DUKE POWER COMPANY

Re: McGuire Nuclear Station
Docket Nos. 50-369 and 50-370
Revised Requests for Relief from ASME Code Section XI Requirement Determined
to be Impractical

REQUEST FOR RELIEF FROM ASME CODE SECTION XI REQUIREMENT DETERMINED TO BE IMPRACTICAL

REQUEST FOR RELIEF FROM ASME CODE SECTION XI REQUIREMENT DETERMINED TO BE IMPRACTICAL

Figure 1

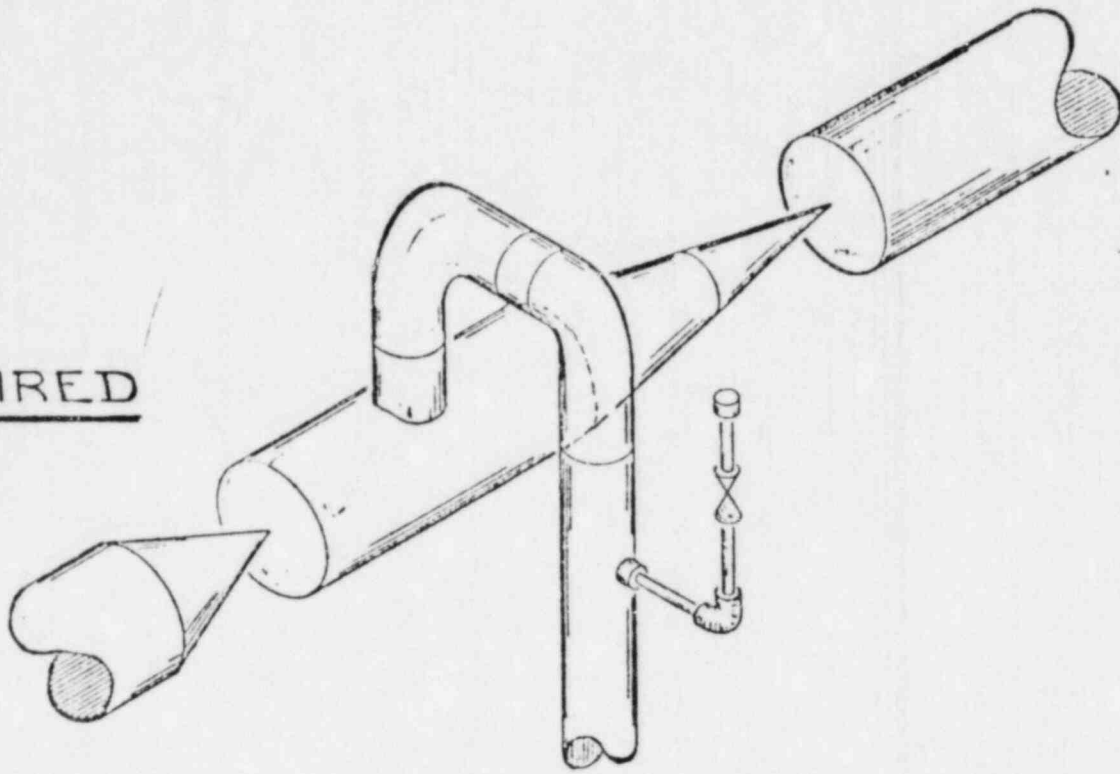
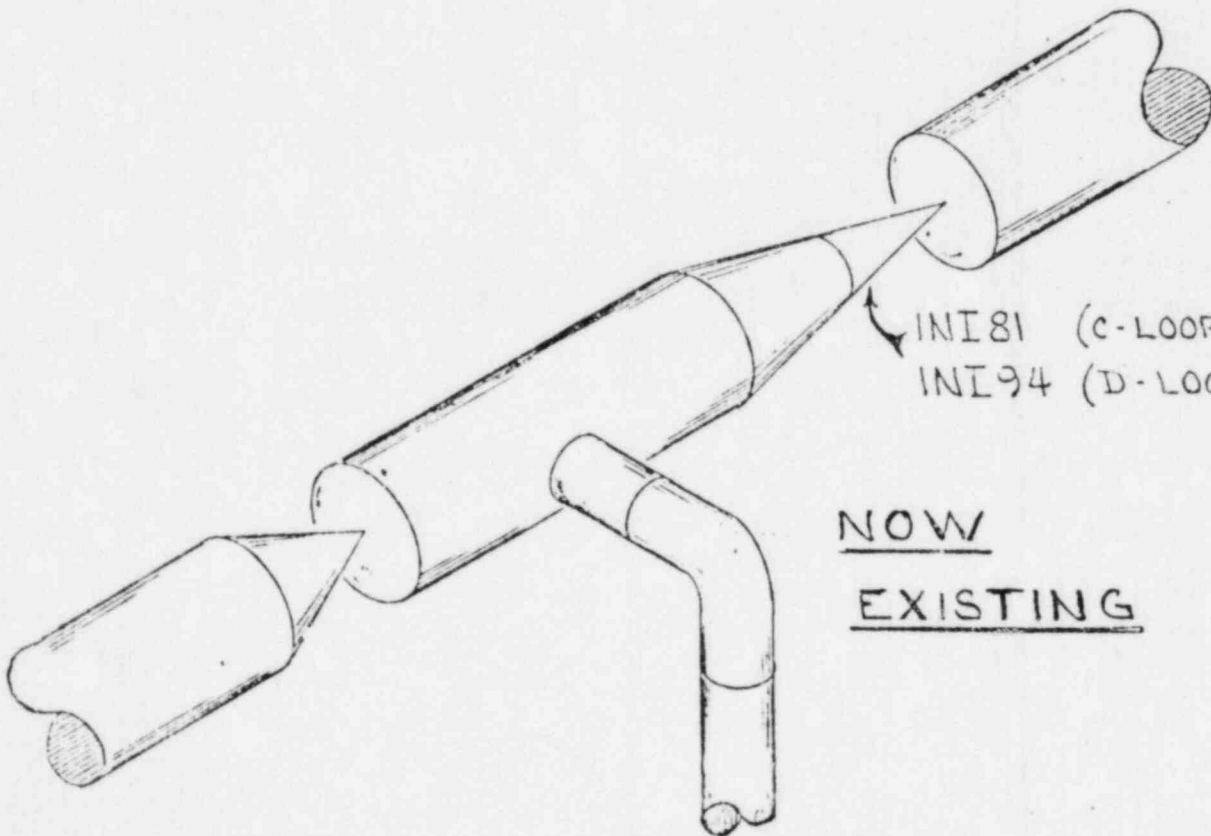
Unit One safety injection system piping is to be modified in order to prevent the primary and secondary check valves to the reactor coolant system from fluttering.

The Tee will be rotated and welded between the 10" check valves (SA 351 CF8M - P No. 8 Group 1) - then the 6" elbows and pipe will be welded.

There are two affected areas of piping in the system. One area is between two check valves, and the other area is identical (reference Figure 1). There are no isolation valves downstream of these primary and secondary check valves to the NC system, therefore it is impossible to isolate these portions of systems. However, there are several approaches to partially pressurizing the system.

The first approach would be to pressurize the (NC) Reactor Coolant System to 2235 pounds, and then use the (NI) Safety Injection pumps to pressurize the NI Systems against one of the check valves. However, this pump pressure is only 1600 pounds, which falls far short of the required test pressure.

The second approach would be to remove the internals from the primary check valves, which go to the NC System, and then pressurize the NC System to 1.02 of 2235 pounds @ 500⁰ temperature. However, this method would still not achieve the desired test pressure per the code, because this would be a dead leg pipe with no flow, and the convective and conductive effect of heat transfer possibly would not reach the 500⁰ temperature minimum, as this portion of the system is uninsulated. This would also require draining the system in order to replace the internals into the check valve, a very timely and very costly procedure.

Therefore, due to orientation of the valves within the system, it is not possible to hydrostatically test the system. However, the alternate examinations as specified in Item 4 are equal to or better than the required testing per the code.

A 100% radiographic examination of all pressure boundary welds, with additional PT examination on root pass welds, and also final pass welds.

Also, a hydro test will be performed at the 10-year inspection interval per Section XI of the ASME Code. An inservice leak test cannot be performed on this system because if the check valves hold, the system will not see system pressure. In addition a UT examination will be performed on the welds for Preservice Baseline Inspection per ASME Section XI.
